LR-N04-0002

**INSERVICE INSPECTION PROGRAM
HOPE CREEK GENERATING STATION
FACILITY OPERATING LICENSE NPF-57
DOCKET NOS. 50-354**

**SUBJECT: REQUEST FOR ADDITIONAL INFORMATION RESPONSE -
HOPE CREEK GENERATING STATION RELIEF REQUEST HC-RR-B12 (TAC
NO. MB8407)**

REQUEST FOR ADDITIONAL INFORMATION
HOPE CREEK GENERATING STATION

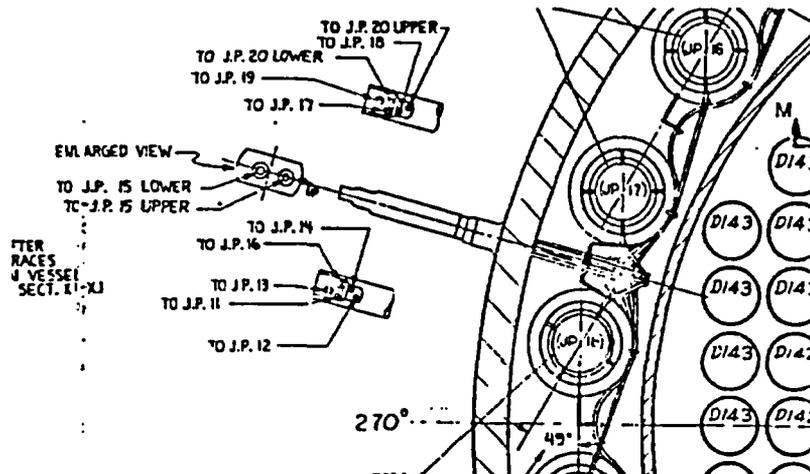
- 1. The April 14, 2003 submittal provided a precedence (Fermi Unit 2) for their relief request. The precedence contained a request for relief from UT to enhanced VT-1 with a 100% coverage and another request for relief from UT to enhanced VT-1 with less than 100% coverage. The staff's safety evaluation considered the coverage and sample size from the request with 100% coverage when reviewing the request of less than 100% coverage. Identify other RPV inner nozzle radii that were essentially 100% examined with enhanced VT-1 (referenced previous safety evaluation). What percent of coverage were you able to achieve during the first interval using UT?**

During Hope Creek's first inspection interval the reactor pressure vessel (RPV) inner nozzle radii were essentially 100% examined using manual UT at the cost of significant personnel exposure. Hope Creek performs automated UT of the Feedwater nozzles and expects to continue doing so per the requirements of NUREG-0619.

The remainder of the RPV nozzles inner radii receives a manual UT from the reactor vessel's external shell surface and nozzle bore regions. In PSEG's April 14, 2003 request, it was indicated that dose rates for specified RPV nozzles were in the range of 200 mR/hr to 250 mR/hr with shielding in place. During Hope Creek's RFO11 (Spring 2003), several of the RPV nozzles exhibited significantly elevated dose rates. The nozzles average dose rates ranged from 250 - 300 mR (nozzle N2) to approximately 9.0 R (nozzle N17) on contact. The manual UT exams are performed from within each nozzle's door opening and contribute to higher personnel radiation exposures due to the examiner's close proximity to the

The sketch below demonstrates the N8A and N8B typical reactor vessel jet pump instrumentation nozzle design that retains the twelve (12) jet pump instrument tubes as shown emanating from the nozzle as shown.
